SUBJECT: REPORT OF TRIP TO ALDEN LABORATORY ON JANUARY 17 AND
18, 2006, TAC NO. MC8434

A meeting was held at Alden Research Laboratory, Inc. on January 17 and 18, 2006 to obtain information pertaining to the review of the application of the Caldon Checkplus ultrasonic flow meter for a power uprate at the Seabrook nuclear power plant. My trip report covering this meeting is provided in the enclosure.

Meeting at Alden Research Laboratory, Inc. On January 17 and 18, 2006 to Review Application
of the Caldon Checkplus Ultrasonic Flow Meter (UFM) for a Power Uprate at the Seabrook
Nuclear Power Plant

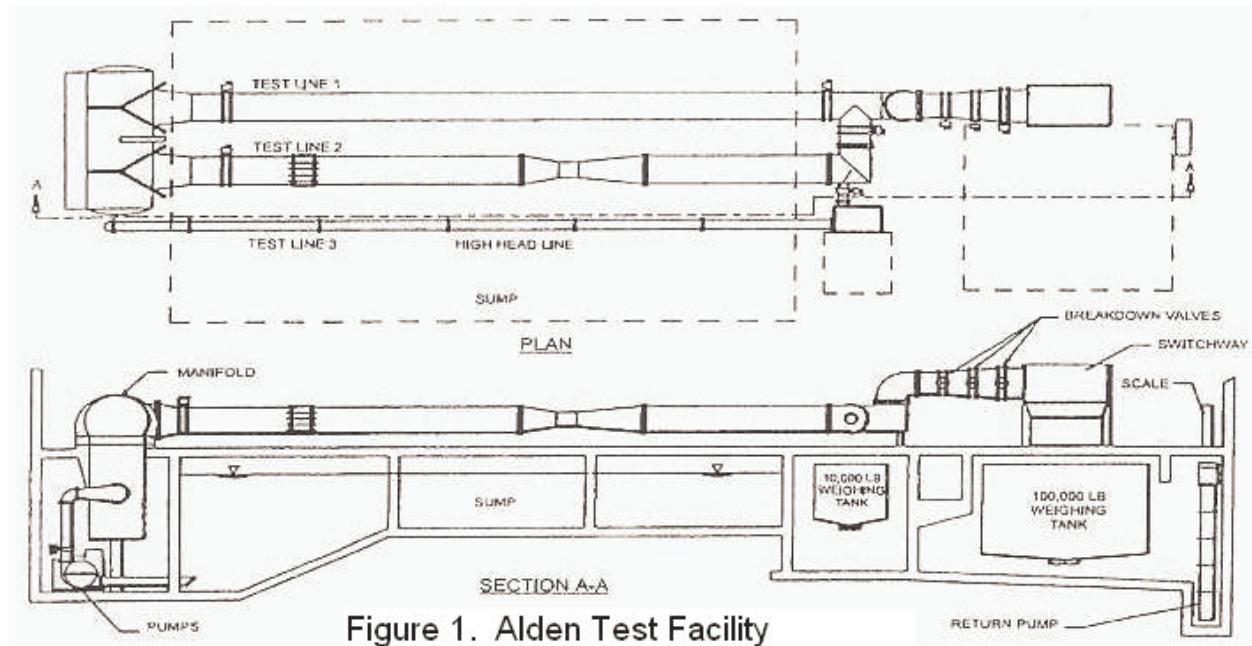
Flow from the pumps into the manifold and from the manifold into the two test sections occurs over a short path with abrupt turns. This introduces the possibility of noise, poorly developed flow profiles, and swirl in the test sections; all items of concern with UFM's but that are of lesser concern with testing other devices.

Figure 3. Seabrook Test Configuration

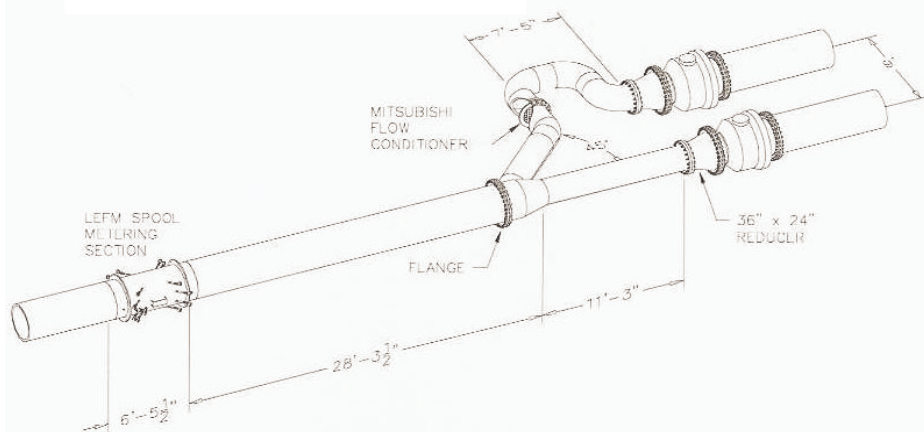
1. Seabrook's specifications for the Checkplus are 16,400,000 lbs/hr @ 447 °F (Reference D). This corresponds to close to 40,000 gpm or 20,000 gpm per feedwater train. With the exception of Test B-4 with full flow through the half-moon, the B series tests are with flow rates of roughly half what Seabrook specified for total flowrate capability. This is an open item that we are reviewing.

2. Water temperature during the tests was approximately 95 °F. The operational specification is 447 °F. This is an open item that we are reviewing.
3. Test A-1 covers the extreme condition of feedwater limited to one feedwater path. The full flow test through the half-moon covers the extreme condition of feedwater from the other feedwater path with the additional complication of introduction of swirl. These bracket the operational configurations that will be encountered during plant operation.

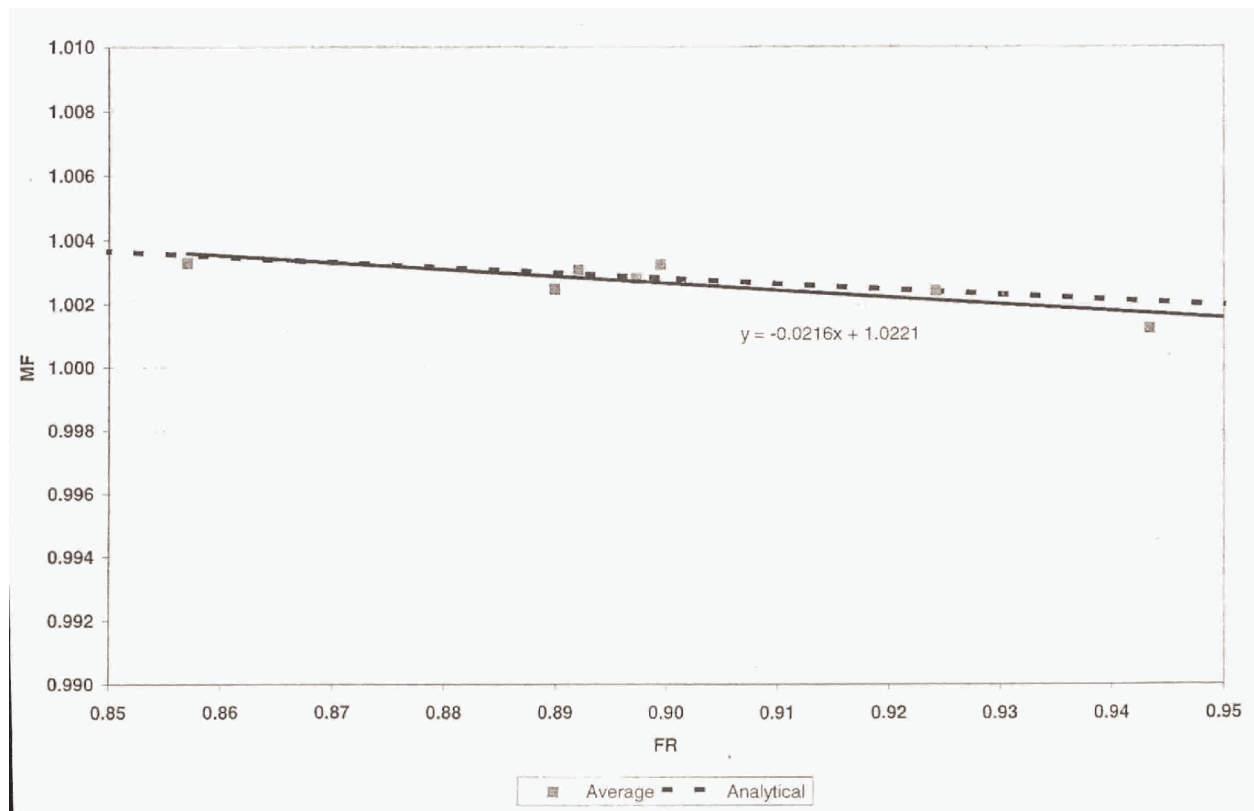
Caldon uses the Checkplus output to compensate for flowrate changes and swirl and no longer uses a Reynolds number extrapolation to extrapolate UFM correction factor to plant conditions. This approach appears promising but I have not completed my evaluation of these processes and have not reached any findings. Consequently, there is little coverage of these topics in this report.

As a further example, preliminary test results are provided in Figure 5 that show correction factor (that Caldon defines as MF) as a function of FR for a range of conditions. Further, Caldon has also used Checkplus results to determine the influence of swirl on correction factor.
